Response to Specific NRC Questions on TXS Service Unit – U.S. EPR

Shelby Small – I&C Systems Engineer
Aug. 30, 2010

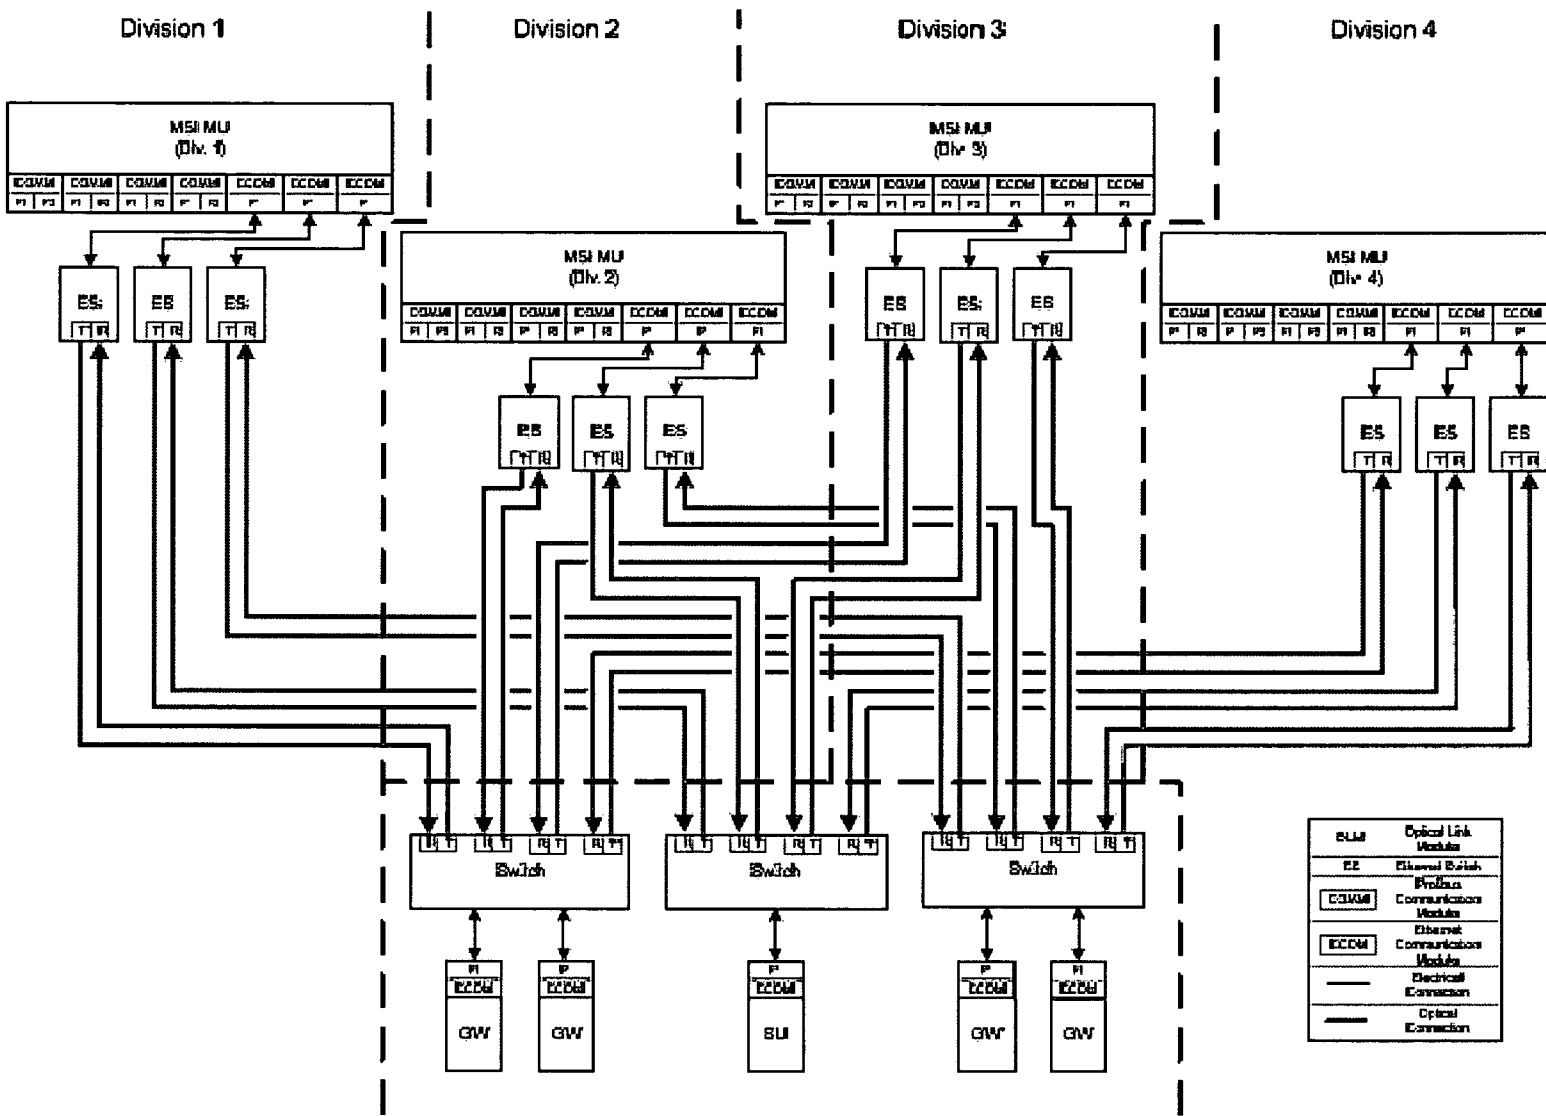
- ◆ **How is the service unit physically connected to the safety systems (i.e., network connections, equipment, etc.)? How does this physical arrangement make their proposal the best option from a safety standpoint?**

- ◆ **The proposed arrangement is acceptable from a safety standpoint because the safety functions are protected from adverse influence by the service unit.**
 - The safety related MSI is the isolation barrier that prevents failures of the service unit or the service unit network from affecting the plant safety functions.
- ◆ **The critical design features that protect against adverse influence from the service unit were presented in detail during the July 21 public meeting on the service unit.**
- ◆ **The network configurations for the U.S. EPR protection system service unit connection are shown on the following slide (figure taken from PS Topical Report submittal, March 27, 2007).**
